GE Hitachi Nuclear Energy

MFN 08-332

Subject: Response to Portion of NRC Request for Additional Information Letter No. 110 Related to ESBWR Design Certification Application - Containment Systems - RAI Number 6.2-140 S01

RAI Number 6.2-140 S01

Figure 6.2-140S01-1: Containment Pressure Response, 0-10 Days

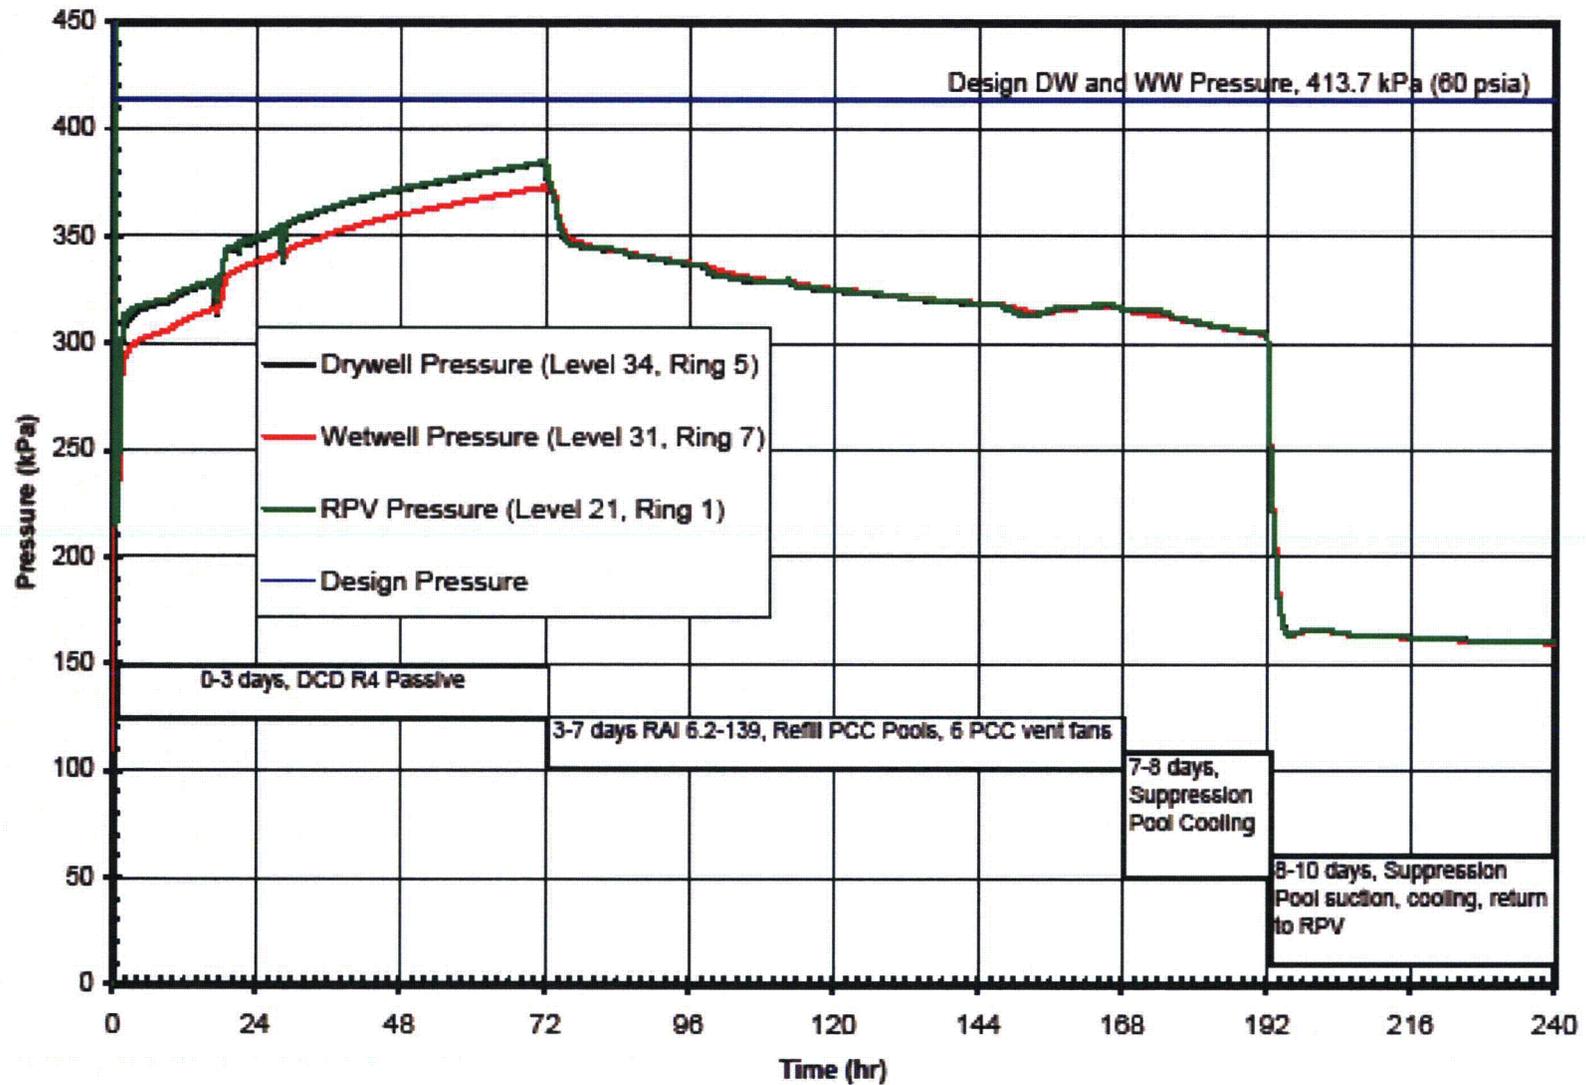
In response to RAI 6.2-140, GEH provided results of containment pressure following a loss of coolant accident that were predicted using TRACG analysis extending up to 7 days. The containment pressure predicted was below the design value for 7 days under the assumptions that the isolation condenser (IC)/passive containment cooling (PCC) pool refill occurred at 3 days and the radiolytic gas production ceased after 3 days. However, the containment pressure appeared to be continuing to rise and could exceed design pressure after 7 days. Further, staff confirmatory analyses also show containment pressure continues to rise and could exceed design pressure before 7 days depending on the bypass leakage that is assumed.

Describe how the ESBWR design meets General Design Criterion 50. Show that resulting containment pressure and temperature following a LOCA can be mitigated sufficiently to reduce and control pressure for the long term. In addition, discuss appropriate treatment of all non-safety systems credited to provide this function after 72 hours, consistent with SECY 94-084.

The ESBWR containment is designed to accommodate, without exceeding the design leakage rate with sufficient margin, the calculated pressure and temperature conditions resulting from any loss-of-coolant accident (LOCA), as required by 10 CFR 50 Appendix A, General Design Criterion (GDC) 50. GDC 50 is met by the ESBWR containment structure, which is designed to accommodate the pressure and temperature of loss-of-coolant accident (LOCA) conditions as calculated and described in DCD Tier 2, Section 6.2. The containment pressure and temperature responses are shown in the attached Figure 6.2-140 S01-1 and Figure 6.2-140 S01-2.

Containment pressure and temperature responses using an example accident recovery evolution using the RWCU/SDC crosstie option are shown in the attached Figure 6.2-140 S01-1 and Figure 6.2-140 S01-2. These response curves credit the RWCU/SDC non-regenerative heat exchanger (NRHX) operating in suppression pool cooling mode for 24 hours beginning at 7 days following a LOCA, followed by vessel injection via the SDC system with suction from the suppression pool. This TRACG calculation starts with decay heat and other containment conditions at 7 days. However, there is no requirement to start these accident recovery options at 7 days since the reactor is in a safe stable shutdown condition, and containment pressure and temperature continue to be maintained with sufficient margin to containment design limits for a sufficient time period to allow for use of other non-safety related, non-RTNSS SSCs to be placed in service to achieve cold shutdown.

The analysis shows that after being in suppression pool cooling for 24 hours, and then injecting into the reactor vessel for approximately 10 hours, the suppression pool temperature reaches equilibrium with the reactor bulk water temperature at 70°C (158°F). Therefore, with the suppression pool temperature being less than 93.3°C (200°F) and in equilibrium with reactor bulk water temperature, the average reactor coolant temperature is less than 93.3°C (200°F) and the reactor is in cold shutdown, which is considered the end of the accident recovery phase. Table 6.2-140 S01-1 lists the RWCU/SDC NRHX data used in the analysis.
